**PRODUCT
SUPPORT
BULLETIN # 454**

TOOL(S) \ PRODUCT(S) AFFECTED: Serial No. Prefix A & B - 5311, 5316, 5316-4 1-1/2" Thunderbolt Rotary Hammer and 5334, 5334-51 Light Chipping Hammer

SUBJECT: substituting a 28-14-2285 or 28-14-2295 Crankcase Assembly for obsolete 28-14-2255 and 28-14-2265 Crankcase Assembly

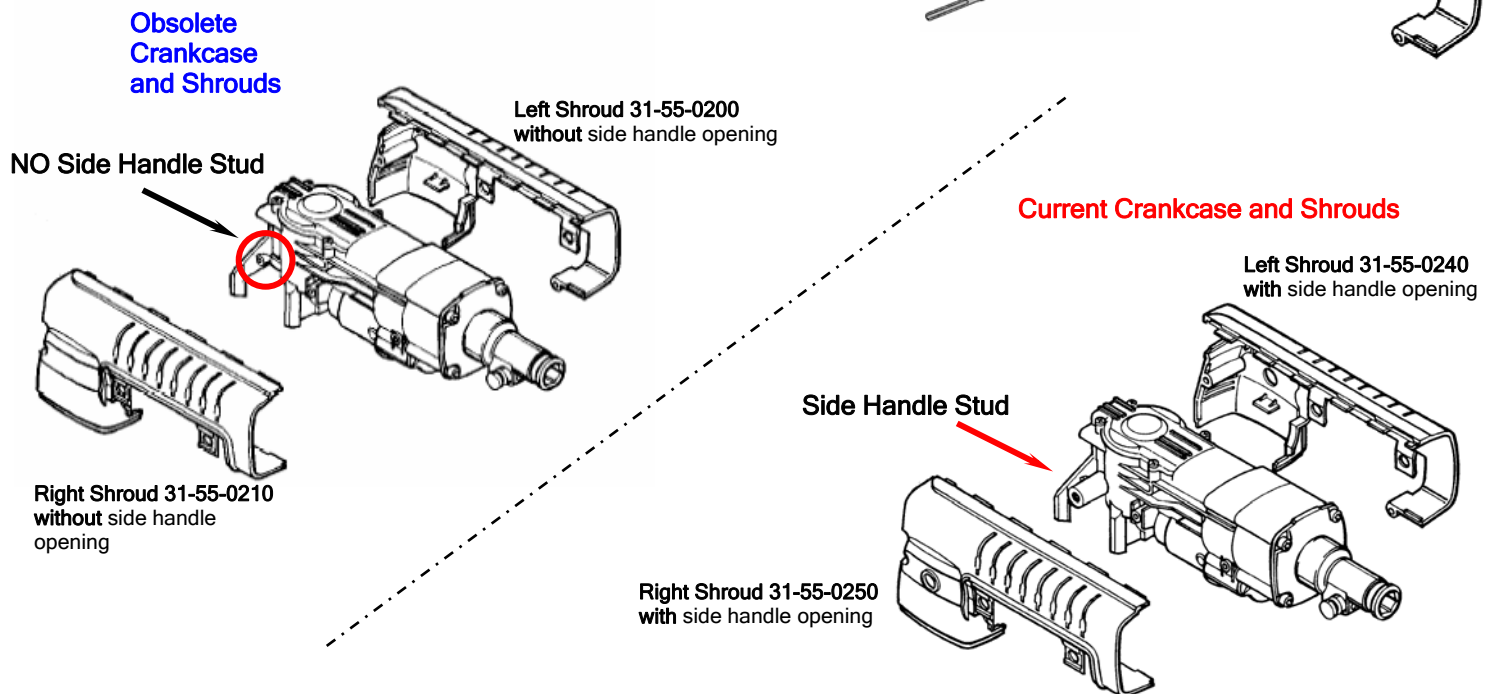
When servicing a Rotary Hammer / Light Chipping Hammer within the revision code / serial prefix A or B and a 28-14-2255 or 28-14-2265 crankcase is needed, crankcase assembly 28-14-2285 or 28-14-2295 can be substituted by performing a minor modification to the original left and right crankcase shrouds using a 7/8" flat boring bit to drill the shroud out to accommodate the two rear side handle studs on the new crankcase

Place the sharp tip of a 7/8" flat boring bit into the center of the recessed area located on the backside of the existing left and right shroud and drill openings in the shrouds.

If either of the original left (31-55-0200) or right (31-55-0210) crankcase shrouds are damaged and can no longer be used, a new 31-55-0240 left shroud or new 31-55-0250 right shroud can be substituted.

Use Crankcase **28-14-2295** when servicing a Rotary Hammers 5316 and 5316-4

Use Crankcase **28-14-2285** when servicing a Rotary Hammer 5311 and Chipping Hammer 5334, 5334-51
